January 26, 2024

**Re: 2023 Annual Inspection Report for Yankee Doodle Tailings Impoundment and Corrective Action Plan for Recommendations**

**Figure 1 Alluvium Facing Placement (MR, 2023b)**

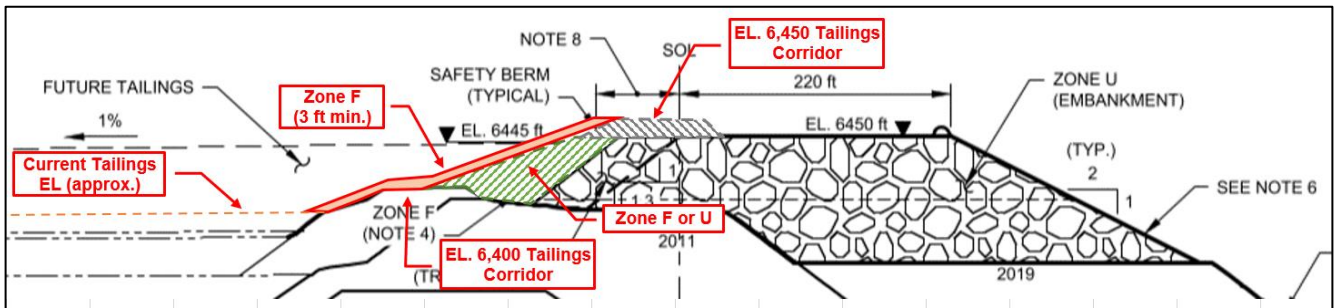
- 2. Continue regrading the upstream slope of the North-South Embankment during construction of the tailings pipeline corridor for EL. 6,450 ft lift. Initial regrading activities were undertaken in 2023 as a result of the 2022 EOR AIR recommendations. Regrade the embankment upstream slope to cover and incorporate the tailings pipeline discharge corridor along the EL. 6,400 ft lift. Implement the alluvium facing layer between the crest of the tailings pipeline corridor along the EL. 6,450 ft lift and the upstream alluvial facing of the EL. 6,400 ft lift along the regraded upstream slope. The intent is to**

**create a continuous layer of alluvium between the EL. 6,450 tailings pipeline corridor and the alluvium facing previously placed as part of the EL. 6,400 ft lift construction. This recommendation applies to the remaining portion of the North-South Embankment between Section 28+00N and the abutment at Rampart Mountain. (continuation of 2022 recommendation).**

MR proposes to continue the upstream slope regrading of the North-South Embankment with the same construction methodology implemented along the East-West and North-South embankments as outlined in the 2022 CAP (MR, 2023b) and illustrated in Figure 1. It is anticipated that the North-South regrading activities will occur in Q1 and Q2 of 2024. The timing and completion of this work will be dependent on tailings beach conditions as the tailings discharges are used to limit and control dusting from the tailings beach to the most practical extent. Regrading activities will require the temporary disconnection of Tailings Delivery Pipeline 3 at a location between the 3-3 discharge and the 3-4 discharge. The Tailings Delivery Pipeline will be reconnected as the facing and construction of the tailings pipeline corridor advanced to the north.
